**BEFORE THE PUBLIC UTILITY COMMISSION  
OF OREGON**

LC 73

2019 Integrated Resource Plan.

Reply Comments of  
Renewable Northwest

- Hypothetical 100 MW Wind Resource
- Same wind resource, with different deliverable scenarios

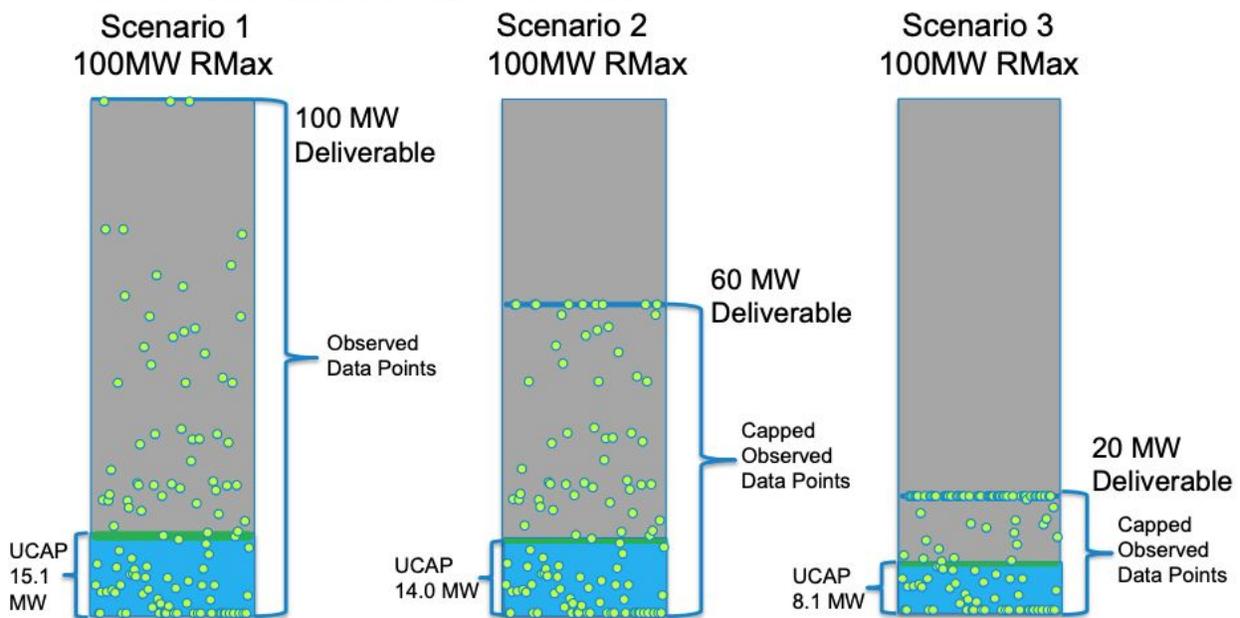
We encourage PGE to explore whether reducing the level of maximum output for which it would require long-term transmission may be warranted. As we noted above, the capacity contribution of a VER is generally below the resource’s ICAP value. Additionally, deliverability using firm transmission service may have diminishing returns. We offer an example of analysis done by Midwest Independent System Operator (“MISO”) as it is considering the level of firm transmission service it will require to ensure deliverability of resources that are relied on for their capacity contribution towards resource adequacy requirements. As the graphic below shows, firm transmission service at 60% of ICAP for a wind resource has a minimal negative impact on the capacity contribution of the resource, as compared to the capacity contribution when the resource has firm transmission service for 100% of ICAP.<sup>9</sup>

In this analysis, the capacity contribution, represented by the Unforced Capacity (“UCAP”) value, is decreased from 15.1 % to 14% when the firm transmission available to ensure deliverability of this resource is decreased from 100% to 60% of the ICAP. Capacity contribution of the resource with 80% firm transmission service would likely be very close to that at 100% firm transmission. We encourage PGE to explore whether 80% of maximum output over long-term transmission is optimal for VERs and what the impacts on a resource’s capacity contribution may be if PGE were to require lower levels. If PGE does not adopt this suggestion for a 2020 renewables request for proposals (“RFP”), we encourage PGE to explicitly identify this issue as one to explore for future renewable RFPs within the 5 years framework for the Interim Transmission Solution.
